EB-2009-0425 – Hydro One Networks' Section 92 Application – Toronto Midtown Transmission Reinforcement Project – Further Response to NRRA Notice of Motion and Response to TDSB Interrogatory Request

**EB-2009-0425 – Hydro One Networks' Section 92 – Toronto Midtown Transmission
Reinforcement Project – Responses to North Rosedale Ratepayers Association List 2
Interrogatory Questions**

EB-2009-0425 – Hydro One Networks' Section 92 – Toronto Midtown Transmission Reinforcement Project – Responses to Interrogatory Questions

Leaside TS to Bayview Jct. Section (Low EMF Design-Optimal Phasing)

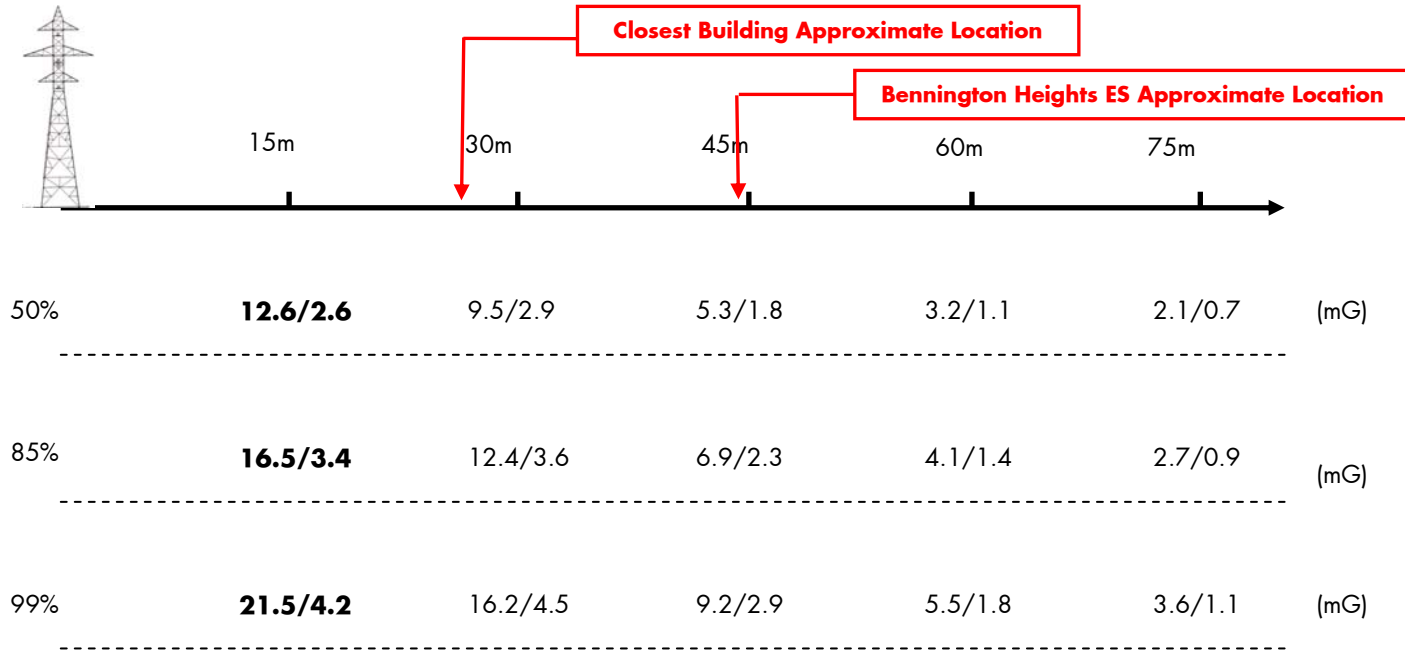
- Distances are measured perpendicular to the north tower line (L14W, L15W).
- Percentages indicate the percent of time when magnetic field is lower than shown.
- Before/after the construction

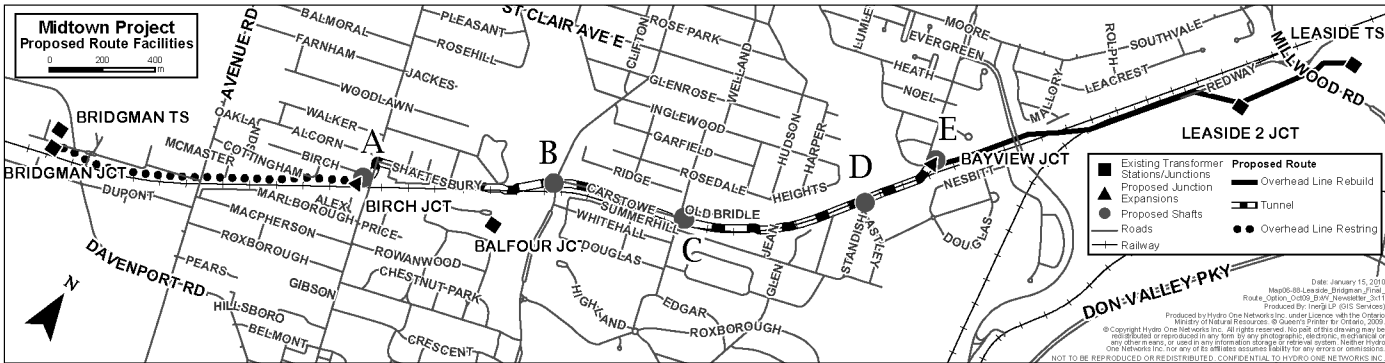
Trenching versus Tunnelling - Section 5.4 briefly discusses two alternative methods of construction to undertake the cable section between Bayview Jet and Birch Jet and certain advantages and disadvantages of each. Section 6 describes the Project as involving construction using the "rock tunnel method and construction of five associated shafts" between Bayview Jet and Birch Jet. However, the ESR does not examine the environmental issues associated with trenching or compare their impact with those associated with tunneling.

Please provide an Addendum to the ESR containing an examination of the environmental issues associated with trenching and a comparison of the environmental impact of trenching and the environmental impact of tunneling.

A comparison of trenching versus tunneling is described in detail in **Section 5.4.1** of the ESR. If the NRRA requires additional information, they should submit a detailed request to Hydro One, as directed in Attachment 1.

Ref: Exhibit B, Tab 1, Schedule 2

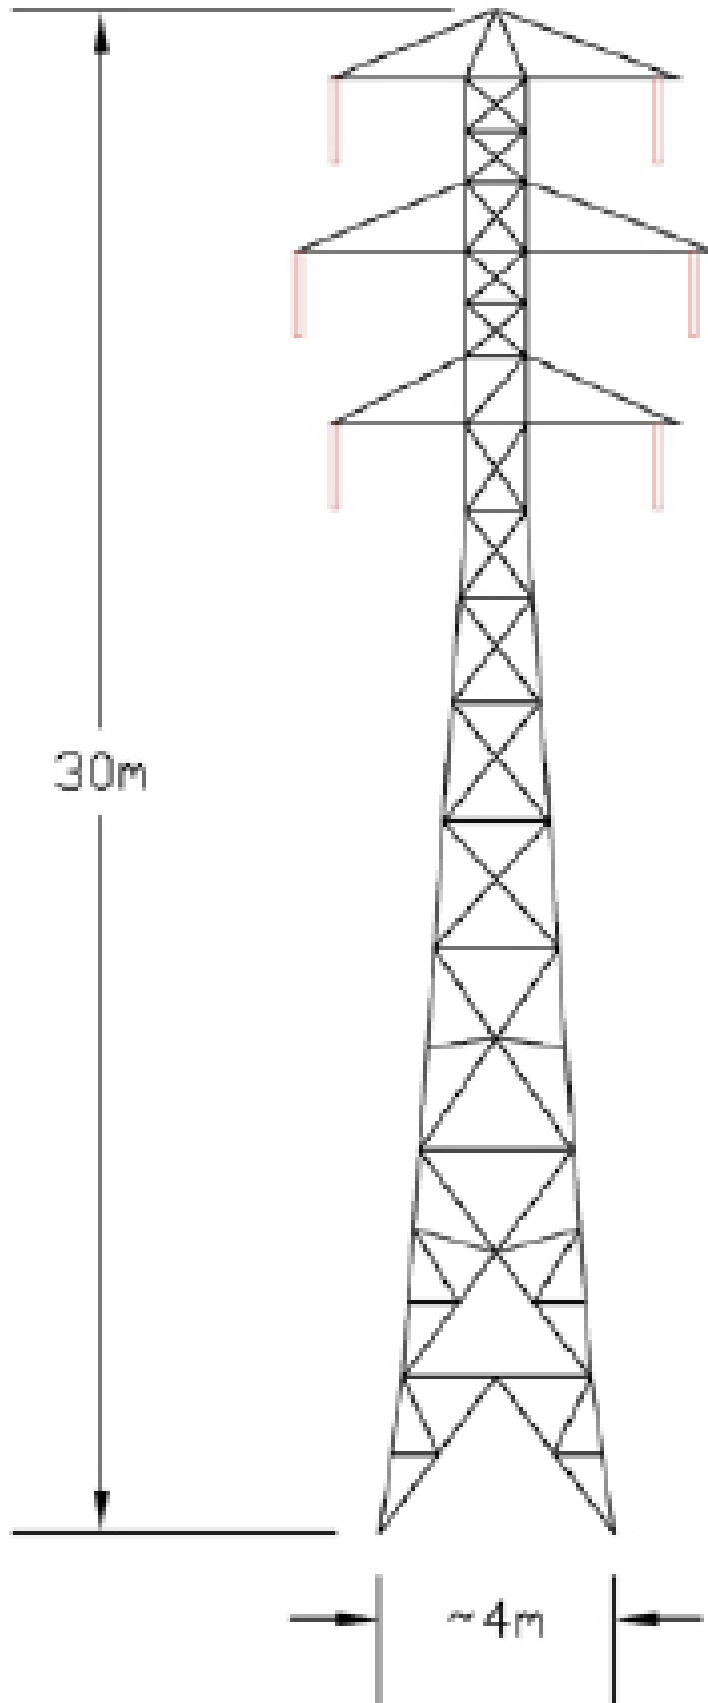
The map of existing facilities shows the three circuits L13W, L14W and L15W. Please provide diagrams showing the tower type and conductor arrangement for each of the tower lines.
